# **Proposal for SAS 2.1 Specification to Enable Support for Active Cables**

**Revision 13**

QUELLAN

January 12, 2009

**Figure 98 — Mini SAS 4x active cable plug connector that attaches to an enclosure out port**

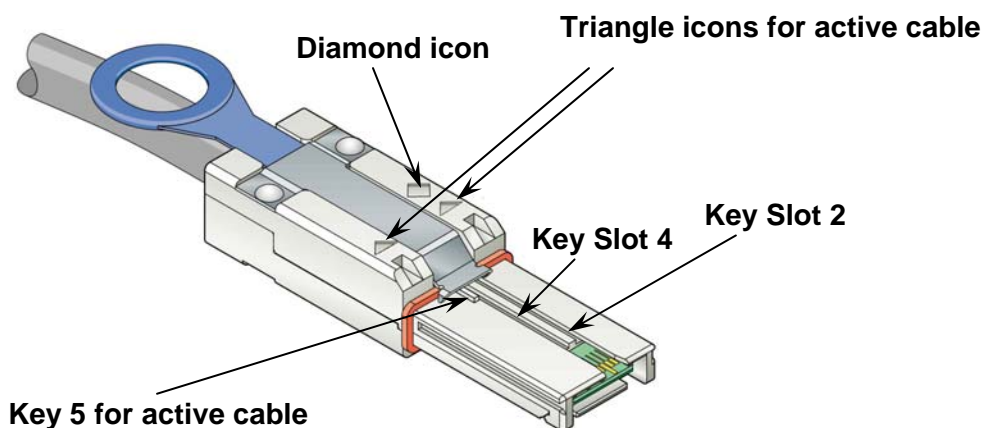
- *Added details of new keying scheme incorporating blocking key in position 5 on the plug and key slots 3 and 5 on receptacle. Updated Figure 98, Table 58 and Table 59 accordingly, added figures 99-101.*
- *Changed the wording in second paragraph of 5.2.7.2.2.1 and second paragraph of 5.2.7.2.2.2 to describe the keying scheme.*
- *Changed the wording of 5.2.7.3.4 from*  
“The active cable power supply shall have protection against the connection of the Vcc pin to ground or over-current loading, and shall limit the output current when the supply voltage drops below 2.3 V.”  
*to*  
“The active cable power supply shall have protection against the connection of the Vcc pin to ground or over-current loading.”

- *Changed details of active plug keying scheme to differentiate between plugs attaching to enclosure in and enclosure out ports. Updated Figure 98, Table 58 and Table 59 accordingly, added Figure 99, renumbered subsequent figures to be 100-102.*

In order to ensure that active cables are not intermateable with passive receptacles, differentiating keying shall be provided by having key slots in positions 2, 4 and 6 and a blocking key in position 5 on the plug connector, and key slots in positions 3 and 5 on the receptacle connector in addition to keys 2, 4 or 6 used identify a receptacle for an enclosure out, in or universal port. In addition, two triangle icons on each side on the plug connector shall be added to the plug connector to identify an active cable assembly. The plug connector key positions and icons are summarized in Table 58.

**Figure 99 — Mini SAS 4x active receptacle connector - end device or enclosure universal port**

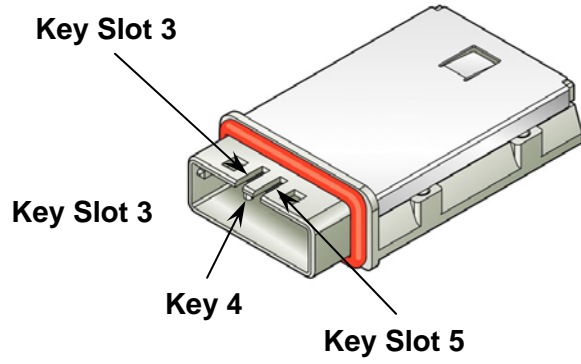
In order to ensure that active cables are not intermateable with passive receptacles, differentiating keying shall be provided by having key slots in positions 2, 4 and 6 and a blocking key in position 5 on the plug connector, and key slots in positions 3 and 5 on the receptacle connector in addition to keys 2, 4 or 6 used identify a receptacle for an enclosure out, in or universal port. In addition, two triangle icons on each side on the plug connector shall be added to the plug connector to identify an active cable assembly. The plug connector key positions and icons are summarized in Table 58.

The receptacle connector key positions and icons are summarized in Table 59.

**Figure M.1 — Dual comparator design for active cable detection**

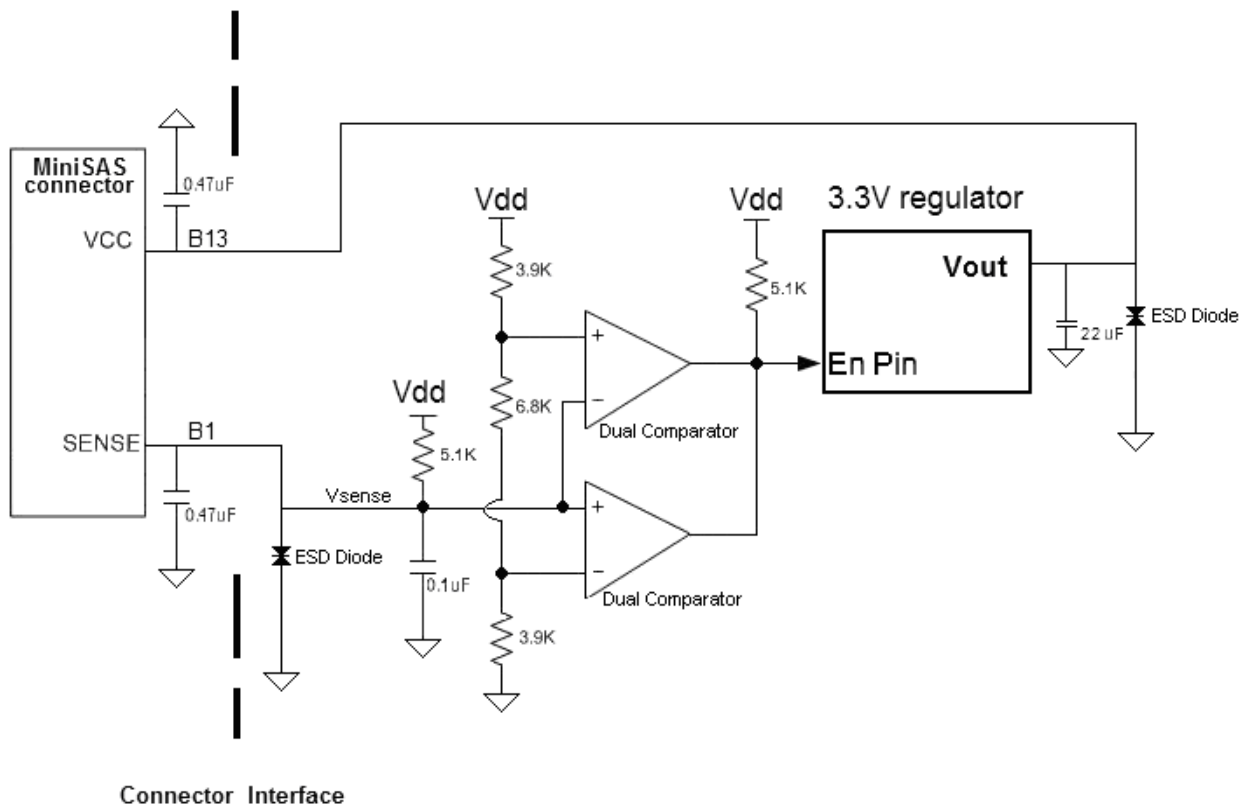
- *Edited most of the wording throughout the document to conform to the T10 style guide and to incorporate comments received from the group*
- *Deleted the minimum value for Supply Current in Table 61 and changed the maximum value from 600 mA to 319.4 mA.*
- *Edited the Informative Annex M to conform to the T10 style guide, dropped Table M.1 (parts List) and edited Figure M.1 to identify the function of the components.*

- *Title and other references to the specification is now 2.1 instead of 2.x*
- *The pinout of active mini SAS cables has been changed in Table 60: the Sense pin is now B1 instead of B10, and pin B10 reverts to ground. The change is also reflected in Figure M.1 of Annex M.*
